Melton East
WURUNDJERI COUNTRY
PRECINCT STRUCTURE PLAN

Co-design Workshop
Summary

APRIL 2023

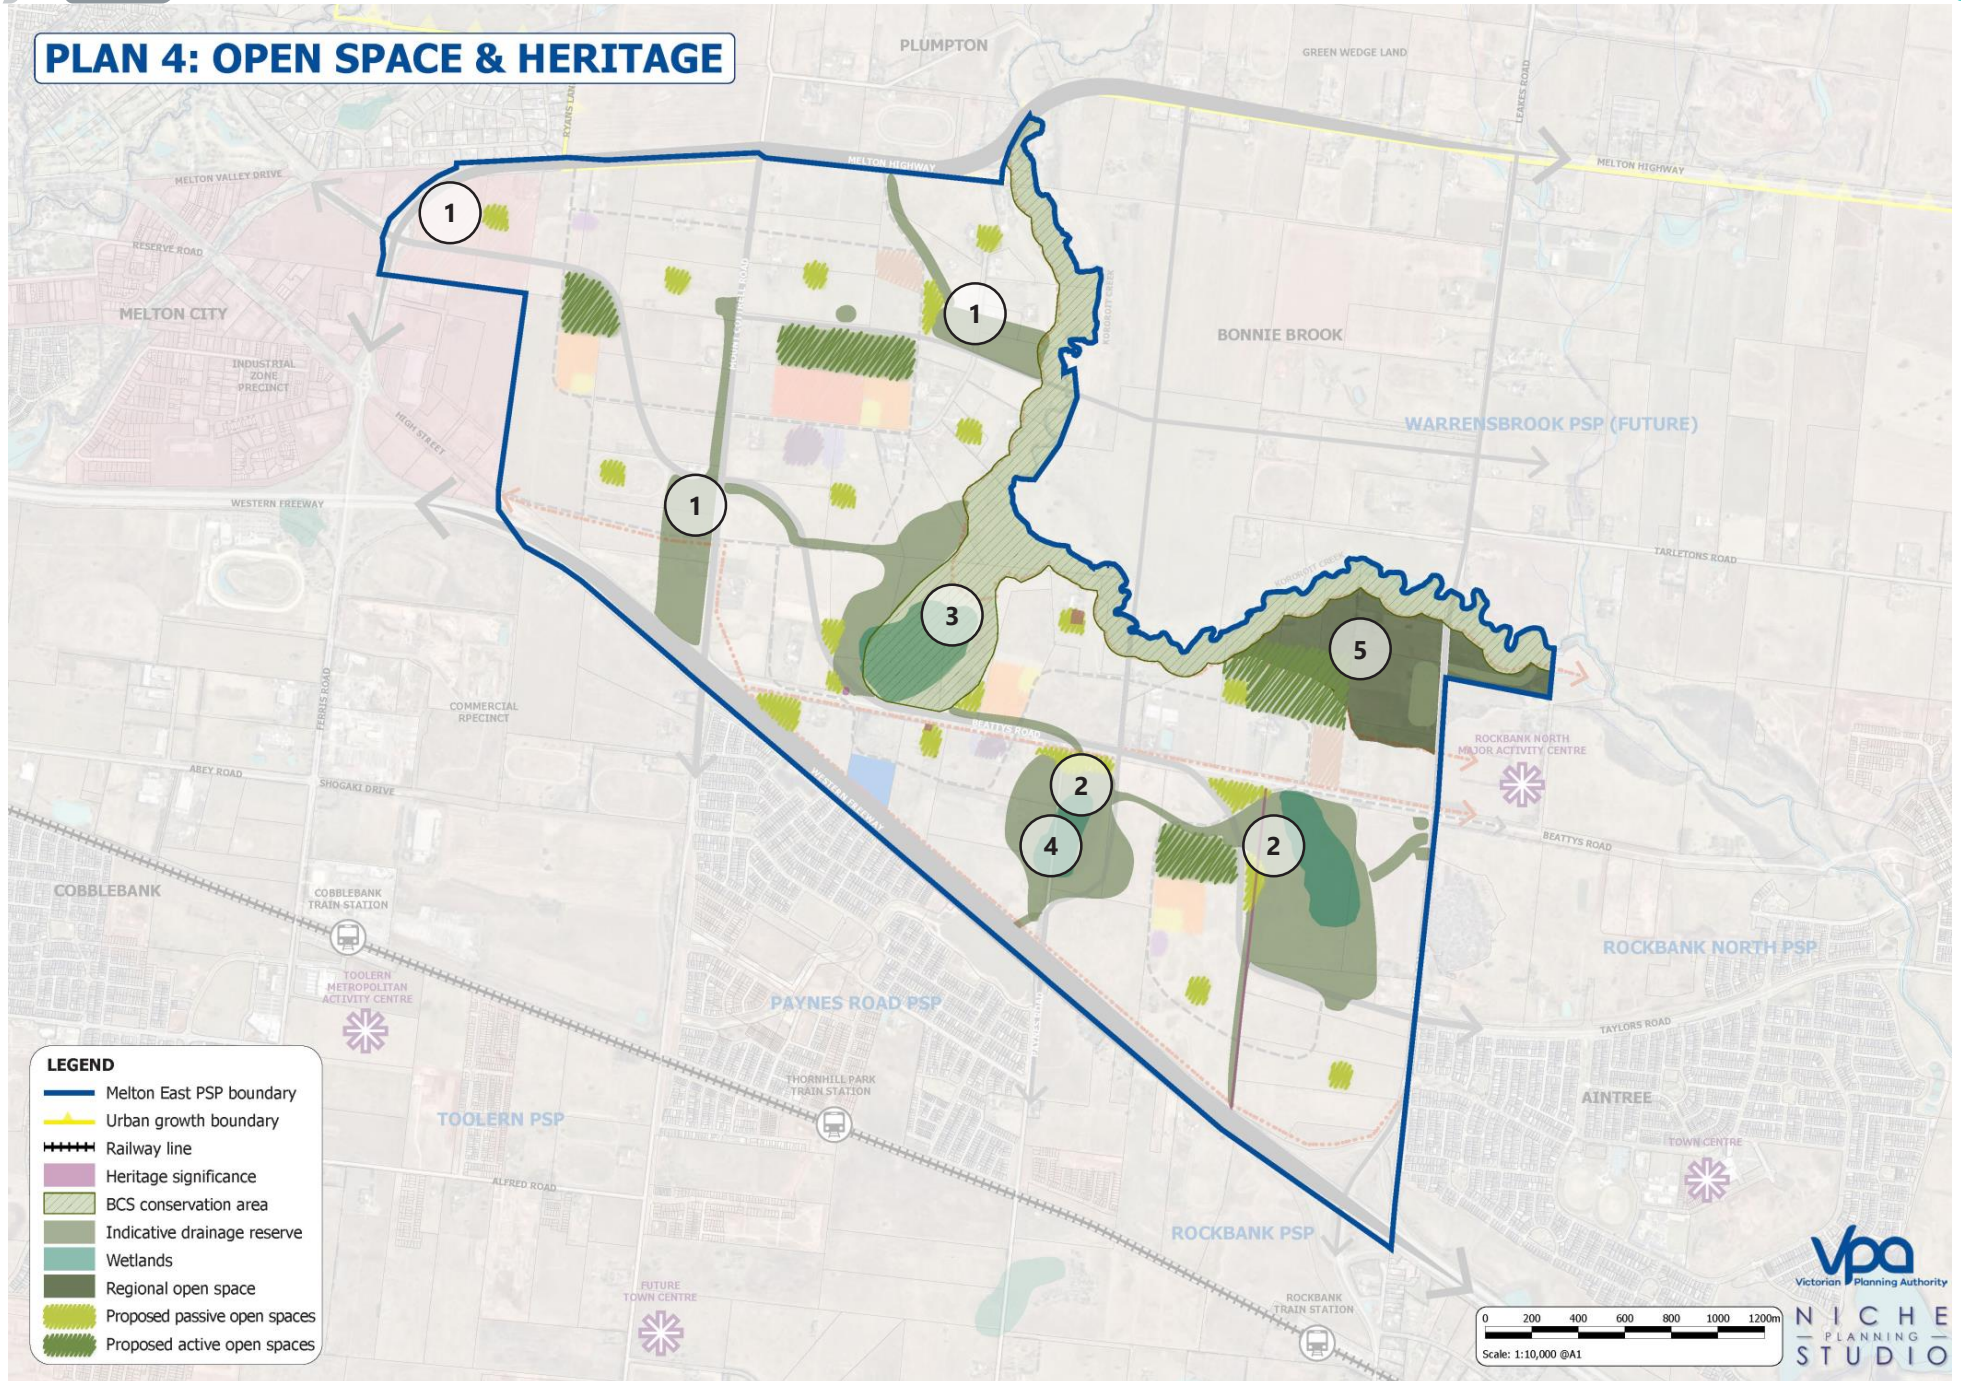
ITEM	DISCUSSION
1	General
	<ul style="list-style-type: none"> Affordable housing requires assessment. There is equitable distribution of net developable area (NDA). Good regional connectivity. Concerns regarding walkability surrounding schools. Opportunity for plan simplification. Need for supported inclusion schools more broadly but not in this PSP specifically. Preferable that kinder and community facilities are adjacent to Department of Education and Training (DET) schools. Co-location with activity centres is good. Potential issues with grass fire. Large area of drainage area in school catchments.
2	Government primary school (precinct west)
	<ul style="list-style-type: none"> Located outside the higher density (400m walkable) catchment from the activity centres.
3	Government primary school (Mt Cottrell Road)
	<ul style="list-style-type: none"> Concerns that the land proposed may be insufficient. Concerns with delayed delivery due to acquisition. Potential drainage risk for community facility and school.

ITEM	DISCUSSION
4	Government primary school (Beattys Road)
	<ul style="list-style-type: none"> Concerns with location on arterial road. Concerns that school setback from Beattys Road with drainage infrastructure is not wide enough.
5	Non-government primary schools
	<ul style="list-style-type: none"> Consider relocating to have better activity centre access. Concerns with school locations, as there may be a larger catchment than anticipated.
6	Government secondary school
	<ul style="list-style-type: none"> Concerns with secondary school walkable catchment.
7	Road/access connections
	<ul style="list-style-type: none"> Strong connections to schools. Connector roads provide good connectivity. Consider how traffic volumes will impact roads surrounding schools. Concerns regarding bus frequency and car parking around schools. Some roads require stronger connections. Pedestrian crossings may be dangerous, in particular primary schools on major roads.

8	Drainage
	<ul style="list-style-type: none"> Drainage reserves providing safer connectivity for children and support shared paths.

ITEM	DISCUSSION
1	<p>General</p> <ul style="list-style-type: none"> • Growth Area Infrastructure Contribution and Works in Kind support for early provision of schools and community facilities. • Opportunity for connections across Kororoit Creek. • Consider higher densities around activity centres and how it will impact traffic volumes. • Support vertical schools. • Opportunity to leverage sports facilities within schools for wider community. • Better integrate schools with open space areas and on active transport routes. • Final activity centre locations will affect school locations.
2, 3 & 4	<p>Government primary schools</p> <ul style="list-style-type: none"> • Schools will be better located adjacent to linear parkland. • Potential for schools to adjoin regional open space and conservation area in east of precinct. • Place schools in area with greatest catchment opportunity. • Consider interface with conservation and residential areas. • Potential to shift school precinct outside activity centre catchment. • Co-locate school, community facility, neighbourhood activity centre and open space.

ITEM	DISCUSSION
5	<p>Non-government primary schools</p> <ul style="list-style-type: none"> • Consider relocation on higher order road as school may have a larger catchment.
6	<p>Government secondary school</p> <ul style="list-style-type: none"> • Investigate potential for an additional secondary school in the south of PSP. • Potential to rotate secondary school in north of precinct to front PPTN to allow for better transport access.
7	<p>Road/access connections</p> <ul style="list-style-type: none"> • 3 metre edges to roads connecting to school (drop-off area). • Provide as many safe walking and cycling paths to as many schools as possible. • Better cycling integration across schools and catchments linking open space, activity centres and off-road reserves (creek). • Consider road cross sections for major arterial roads in terms of access and safety.
8	<p>Drainage</p> <ul style="list-style-type: none"> • Incorporate drainage solutions in school catchment.

PLAN 4: OPEN SPACE & HERITAGE

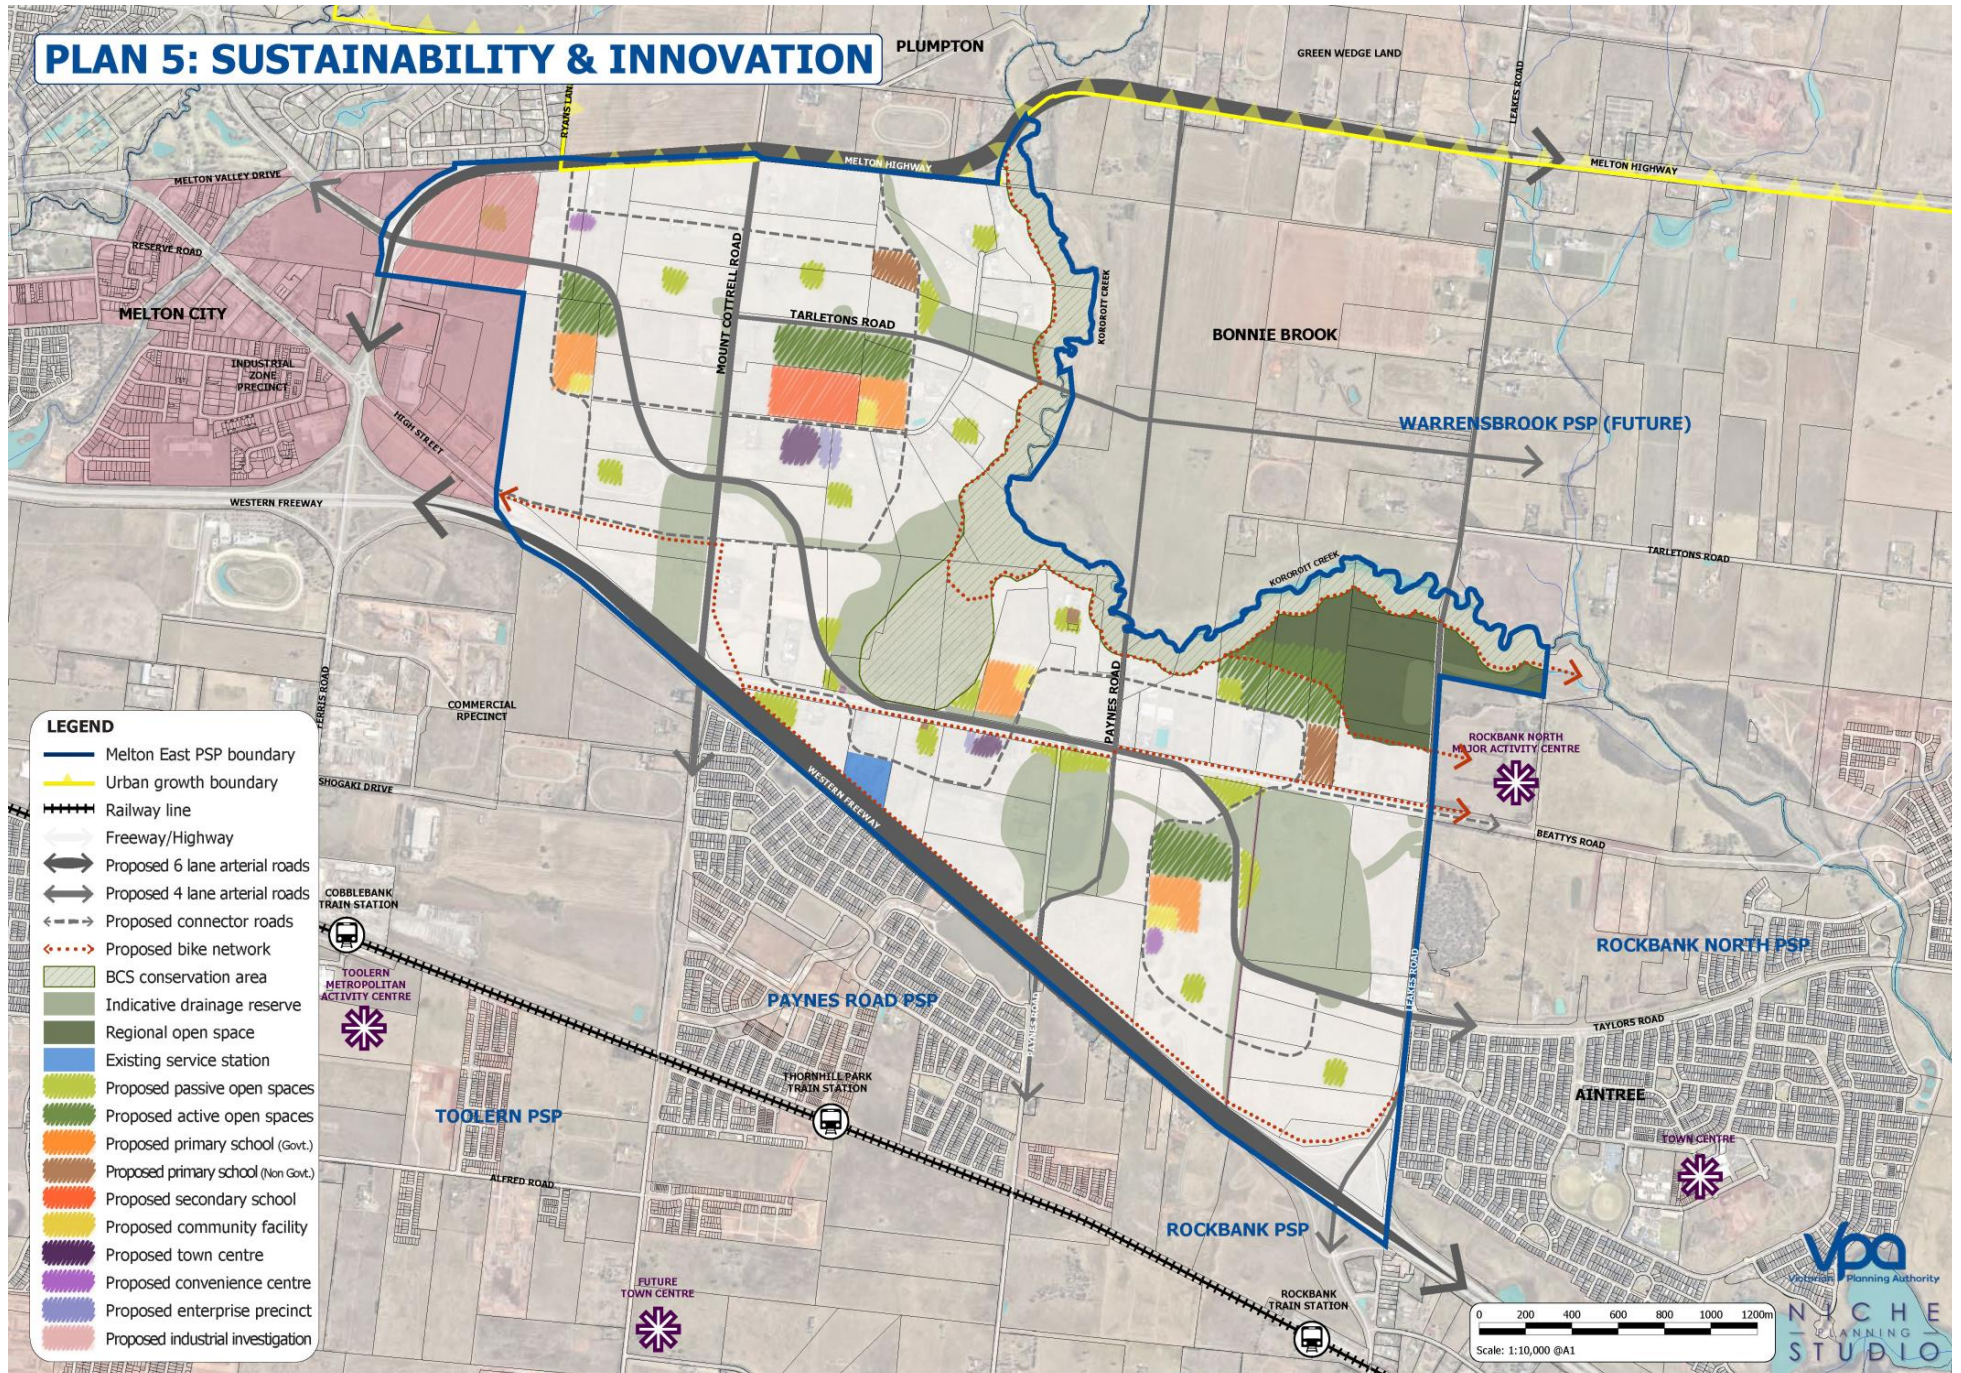
ITEM	DISCUSSION
1	<p>Open space</p> <ul style="list-style-type: none"> • Lots of open space and good distribution of green spaces. • Good linear connectivity through estate. • Good central locations for catchment. • Supportive of co-locating open space in drainage assets. • Well distributed passive open space. • Good to have even distribution of passive open space. • Proposed small open spaces near arterial roads may have poor amenity and not well utilised. • Issues with irregular and inefficient open space areas. • Potential to reduce open space allocation by utilising drainage reserves. • Open space in the middle of industrial area is difficult to service.
2	<p>Wetlands</p> <ul style="list-style-type: none"> • Concerns with drainage infrastructure in linear open space in south-east corner of PSP which contains the dry stone wall site. • Wetlands and catchment boundary may change depending on connector road alignments. • There are existing natural depressions south of Beattys Road which have been identified with biodiversity values.

3	<p>Conservation area</p> <ul style="list-style-type: none"> • Conservation area offers good protection of Kororoit Creek and seasonal herbaceous wetland.

ITEM	DISCUSSION
4	<p>Drainage – Paynes Road</p> <ul style="list-style-type: none"> • Consider size and orientation of drainage reserve along Paynes Road, possible rationalisation to reduce land take.
5	<p>Regional open space</p> <ul style="list-style-type: none"> • Concerns with regional open space as floodplain has potential to affect infrastructure assets.

ITEM	DISCUSSION
1, 5	<p>Open space</p> <ul style="list-style-type: none"> • Potential to use open space as a separation between government and non-government schools • Maximise green links for connectivity • Link bicycle paths to parks • Consider green spine shadeway solution • Ensure there is a diversity of passive spaces • Potential for linear park along Beattys Road • Consider more regular shaped open spaces and located away from major arterial roads in areas of higher amenity • Consolidate and rationalise open space to ensure spaces are multifunctional.
	<p>Drainage, creek & wetlands</p> <ul style="list-style-type: none"> • Possibility to co-locate drainage and conservation, this will rationalise and free up more development area • Opportunities to use drainage or open space as buffer to freeway • Move constructed waterway to align with Beattys Road • Consider using Beattys Road for overland flow • Integrated Water Management (IWM) to ensure efficient water in area • Flip drainage infrastructure along Mt Cottrell Road to be east-west rather than north-south • Use wetland area for drainage purposes.

- Move open space at heritage site north of Beattys Road closer to Kororoit Creek to act as a buffer between conservation area and heritage building.
- Integrate cultural heritage significance along Kororoit Creek and wetlands.

DRAFT PLACE BASED PLAN

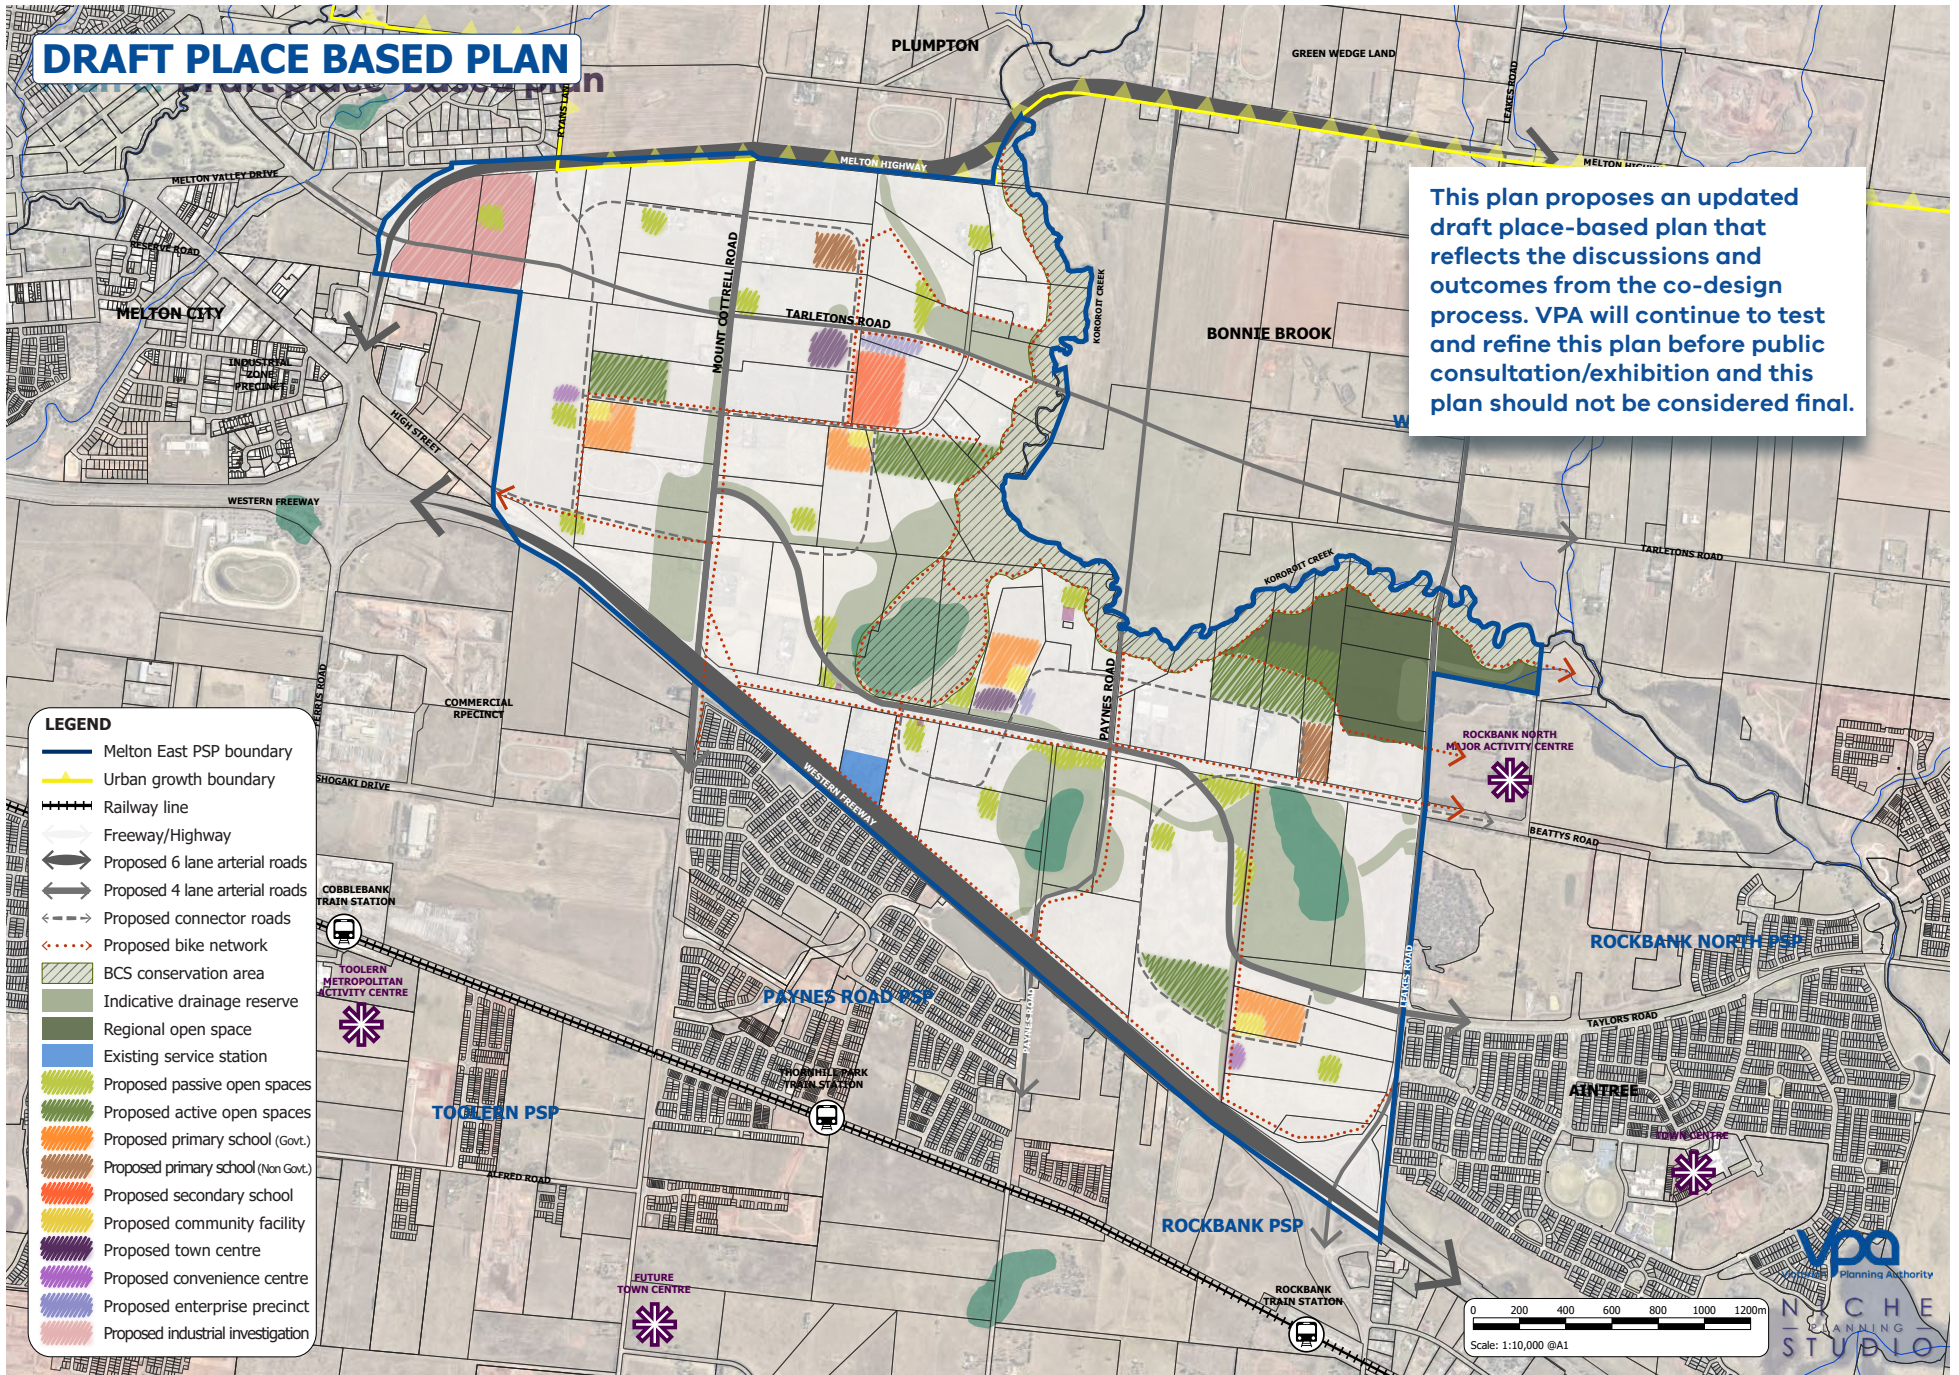
- Straighten out arterial roads
- Active transport links to train station to the south
- Not as many east–west connections
- Realign more north–south roads
- Use existing road reserves
- Pedestrian connections across creek in the north
- Revisit purpose of Taylors Road – amenity
- Better solution for road alignment adjacent to seasonal herbaceous wetland
- Infrastructure contributions plan
- Better cycling and pedestrian connection to activity centres and schools
- Early delivery of rapid bus network
- Mt Cottrell Road overpass priority for pedestrians
- Grid/better connectivity to be revisited
- Extending Tarletons Road through the PSP
- More direct access to activity centres to the east and west

- Distribution change:
 - Relocate north-western NAC along Tarletons Road PPTN
 - Avoid Taylors Road separation between central NAC and primary school
 - Move western LCC further west

- Move eastern LCC further east to better service PSP
- Higher densities around activity centres
- Better linkage of pedestrian and cycling paths between centres

- Better connectivity using Beattys Road to link Rockbank North with new major activity centre. Potential for linear density
- Minimise overlap between activity centre walkable catchments

- Use green areas near activity centres – improved amenity through co-location
- More diverse street and road cross sections to support increased density

- Ensure greater visibility and access to centres
- Minimise water drainage within activity centre walkable catchments
- Investigate mixed use zoning as a buffer between the industrial land west of the PSP and the western LCC

- Investigate rearranging government and non-government primary schools to east of precinct
- Investigate improved co-location of schools to activity centres

- Consider relocating secondary school and adjoining primary school further east for increased residential density around the neighbourhood activity centre

- Co-locate schools with conservation areas/open space
- Move western school catchment east to exclude industrial area
- Separate high school and primary school with connector road

- Co-locate school and town centre north of Beattys Road
- Better integrate schools and open space using PPTN, cycleway and linear parkland
- Move central primary school away from arterial road

This plan proposes an updated draft place-based plan that reflects the discussions and outcomes from the co-design process. VPA will continue to test and refine this plan before public consultation/exhibition and this plan should not be considered final.
